**LAKE PONTCHARTRAIN, LA.
AND VICINITY
LAKE PONTCHARTRAIN
HIGH LEVEL PLAN**

**DESIGN MEMORANDUM NO. 19
GENERAL DESIGN**

**ORLEANS AVENUE
OUTFALL CANAL**

ENGINEERING CORRESPONDENCE LOG

FIGURE 15

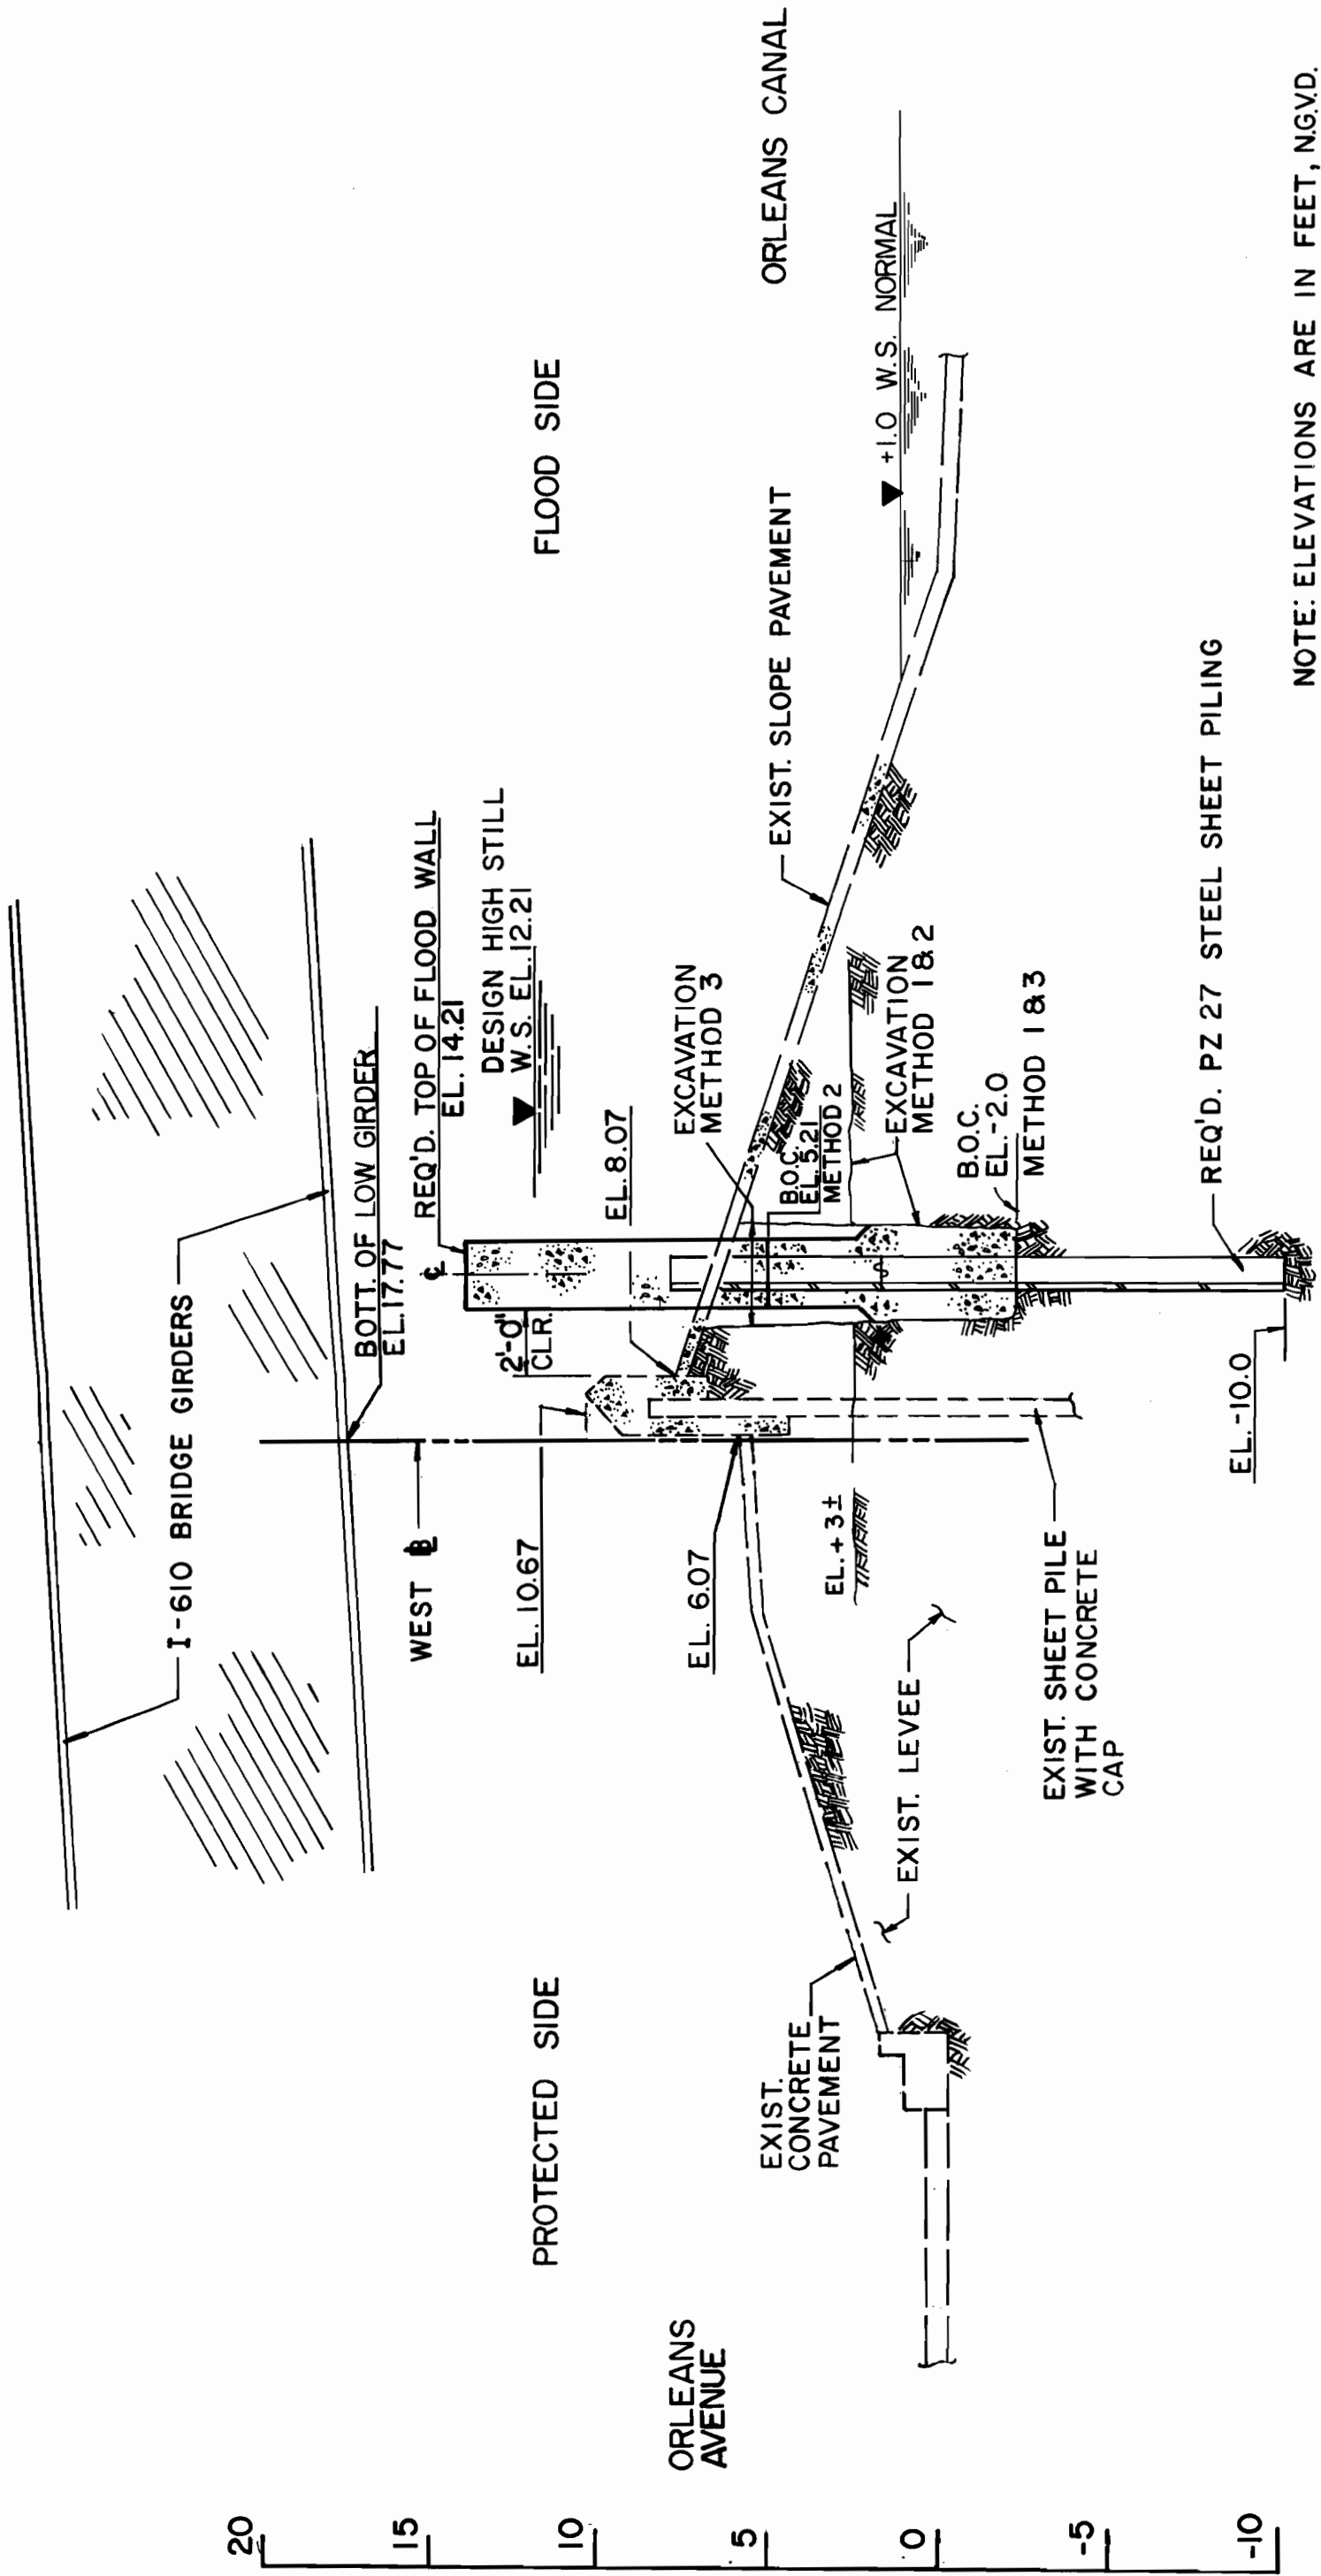
30. Reference chapter VII, paragraph VII A, and figure 15 - The draft geotechnical report for this project did not include any analysis for this reach and the I-wall at the I-610 bridge.

31. On figure 15, the bottom of the concrete cap for method 2 should be 2 feet below the ground surface as required by paragraph IV.D.1.

b. The sheet pile tip elevation for the I-610 bridge modification differs from that shown on Fig. 15. This discrepancy should be resolved.

Comment 30. The sheet pile tip elevation of -10 was shown in figure 15 and stated in chapter VII, paragraph VIIA of the GDM. A sheet pile tip elevation of -20 was used for Reach I west side of the canal while a tip elevation of -1 was used for the east side of the canal in the Draft Soils Engineering Report. Neither of these tip elevations agree with the tip elevation used in the GDM. We do not understand Eustis Engineering's response.

Comment No. 30 - The sheet pile tip elevation shown in figure 15 and stated in paragraph VIIA of the GDM (at I-610 Bridge) has been changed to agree with the tip elevations in the Soils Engineering Report. This change is also shown on the preliminary drawings for Phase II of the project submitted November 25, 1987.

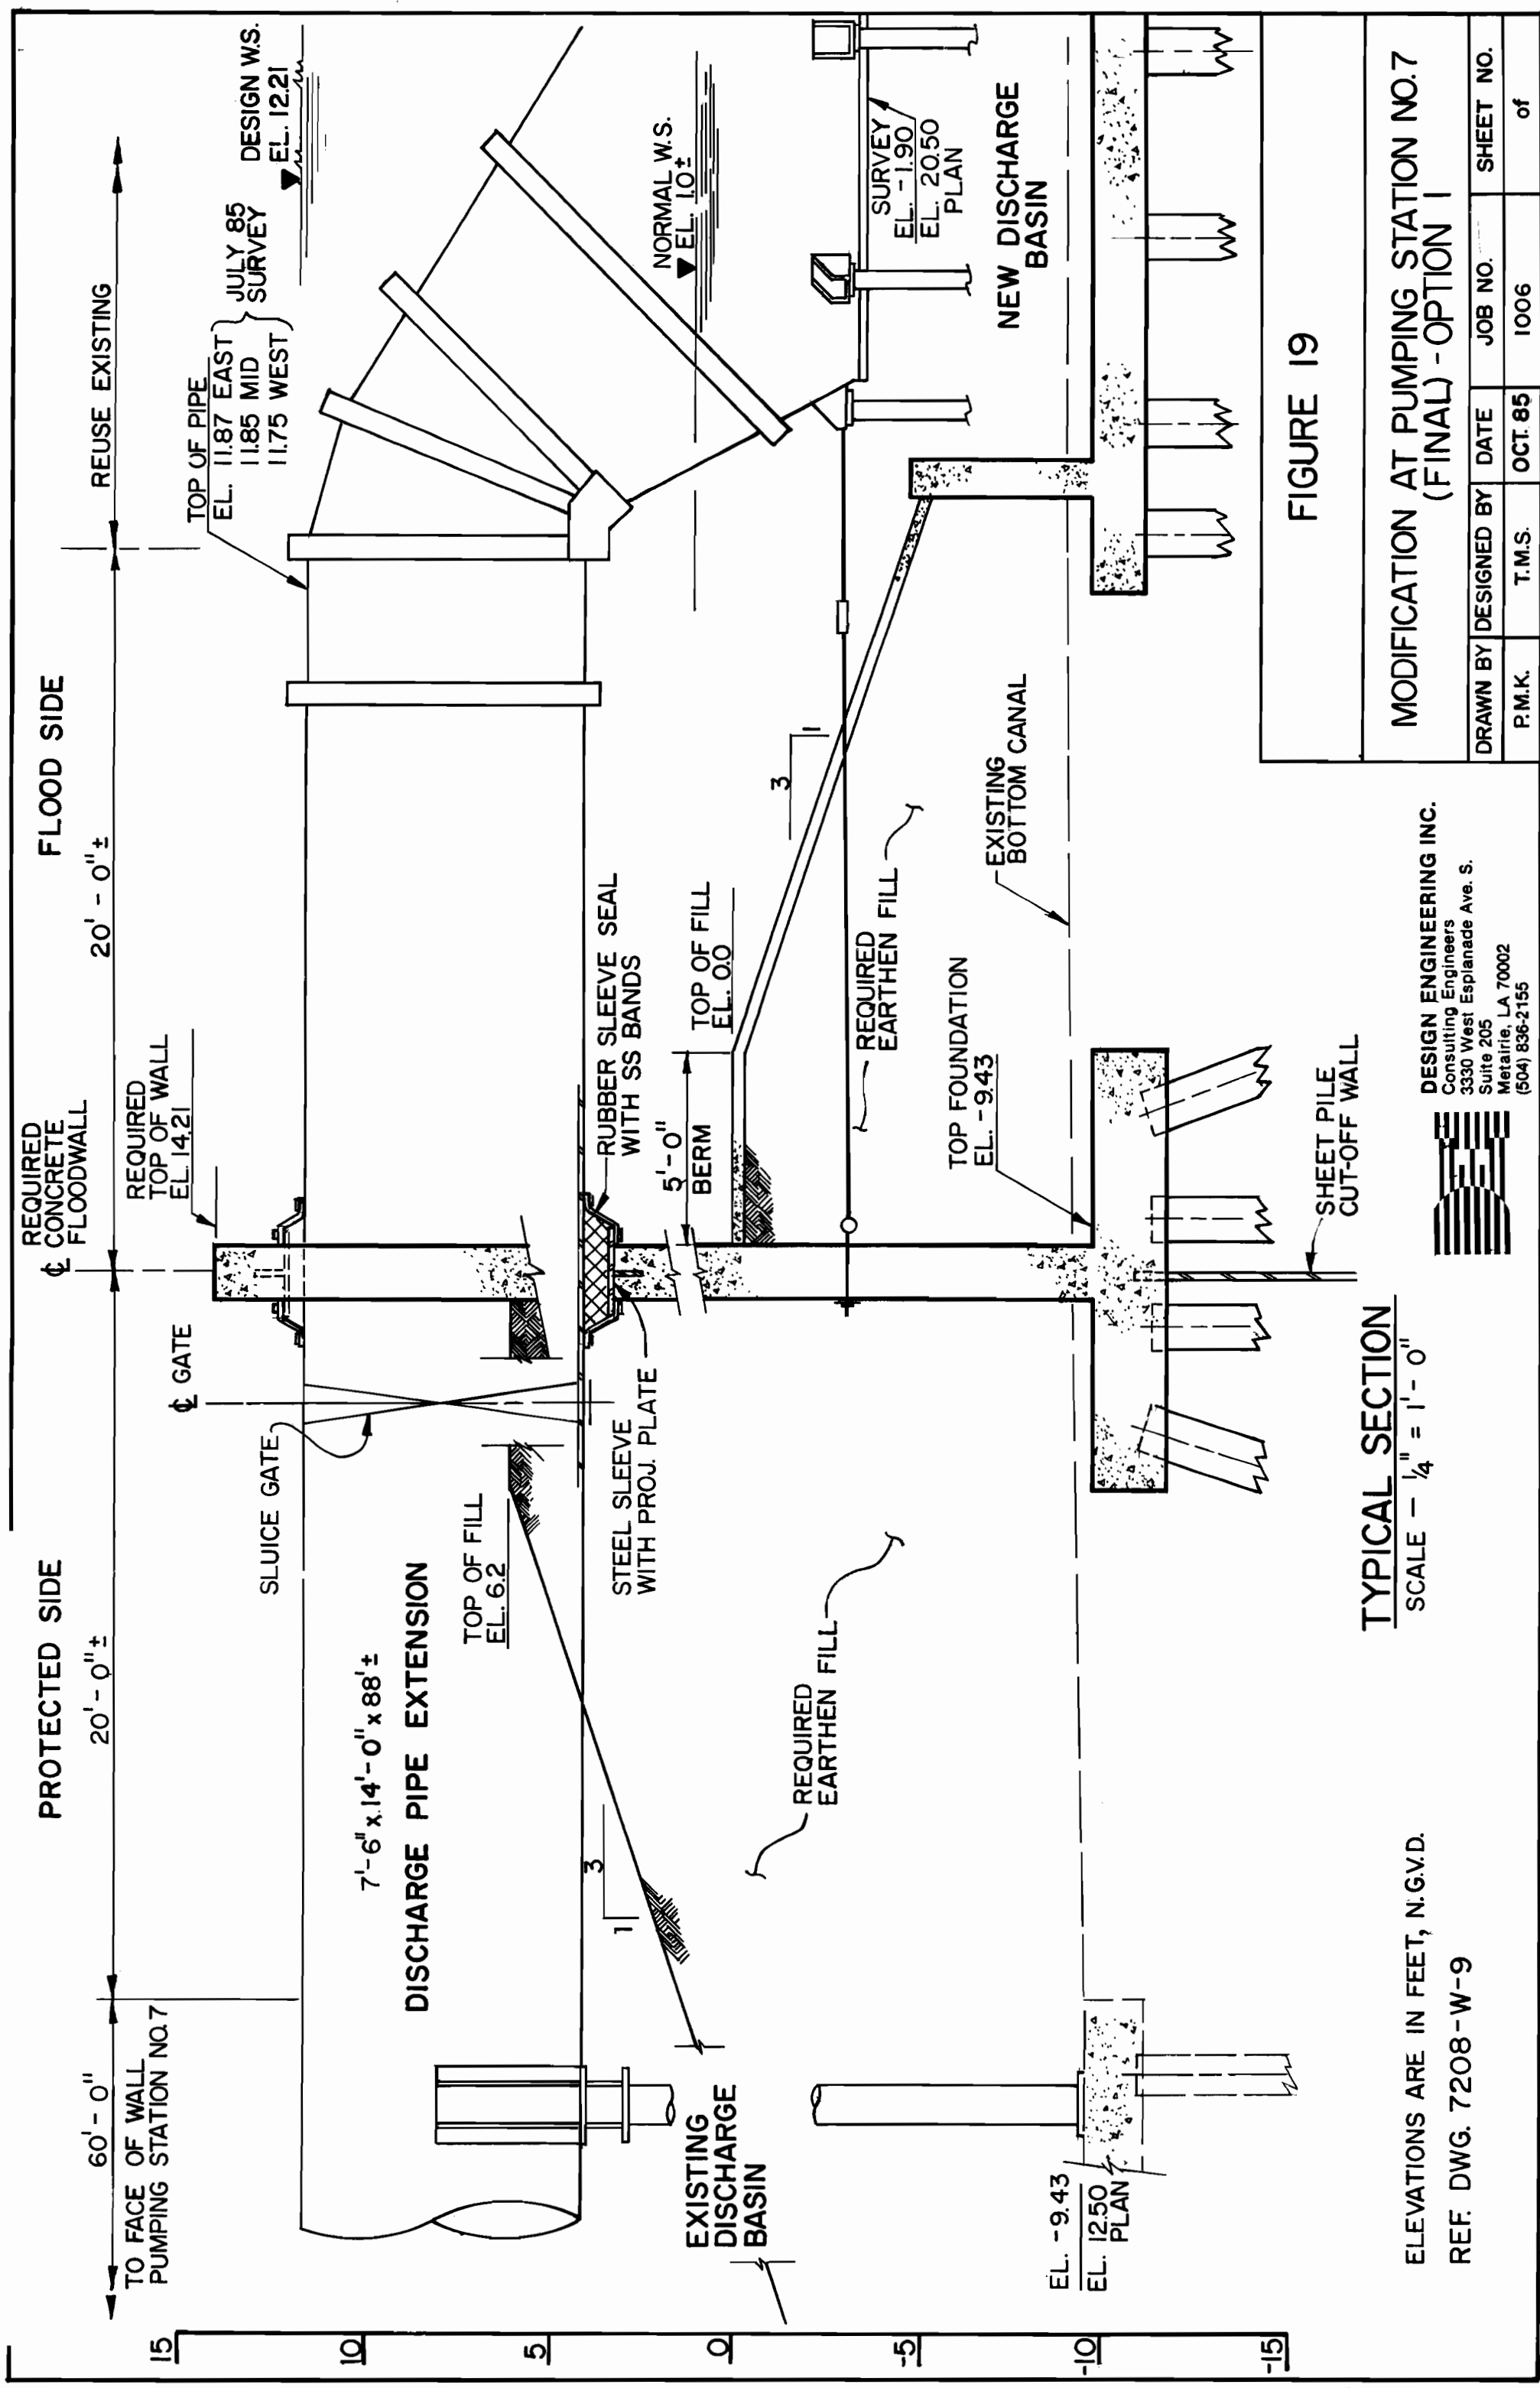
35. Reference figure 19 - Connecting of the discharge pipe to the proposed floodwall is unacceptable. Independent
